Preliminary Subdivision

Cluster Unit Development

Case File / Name: S-39-09 / Ramblewood III

SUBJECT: S-39-09 / Ramblewood III

S-39-09 / Ramblewood III – Preliminary Subdivision Plan

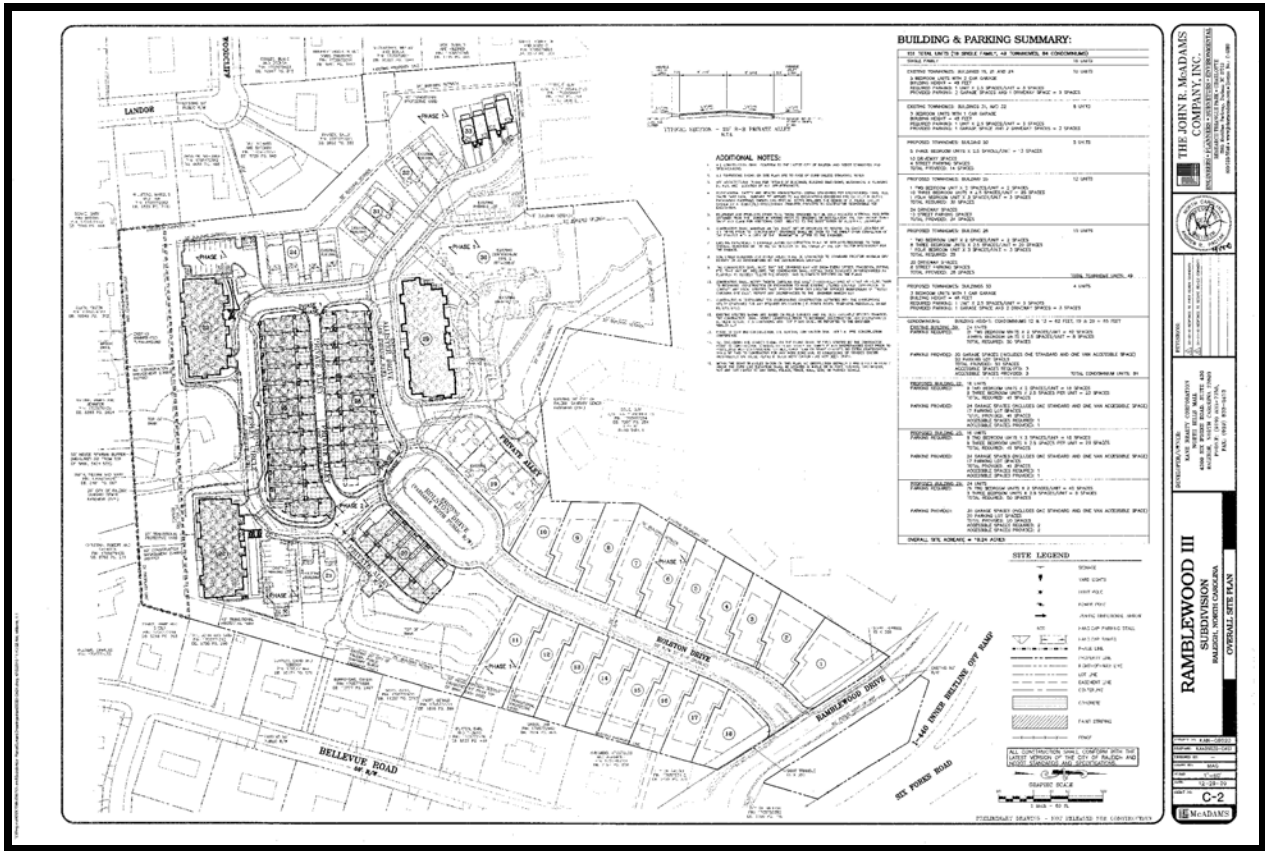
- (1) That construction plans be approved that relocate water tap for Condominium 22 to new water main alignment;
- (2) That the plat to be recorded show:

- I. Neuse Rive Riparian Buffers, in accordance with the preliminary plan and the State of North Carolina regulations, along with a note stating: "Riparian buffers shown on this plat are subject to grading and vegetation removal restrictions in accordance with state law."

- II. Permanently protected undisturbed open space areas, as designated on the final stormwater and nitrogen control plan, used to meet the nitrogen reduction requirements of Part 10 Chapter 9, along with a note stating: "Within permanently protected undisturbed open space areas used for stormwater treatment, there must not be any land disturbing activity, as defined in Part 10 Chapter 2 of the Raleigh City Code, any new development or expansion thereof, or new use, construction, or encroachment without first obtaining a written watercourse buffer permit from the City of Raleigh Inspections Department."

- III. The 40 foot and 100 foot wide natural protective yards specified in accordance with zoning conditions 4 and 5 of Z-38-05.
 - IV. All tree conservation areas shown with a metes and bounds description and labeled on any plat for recording.
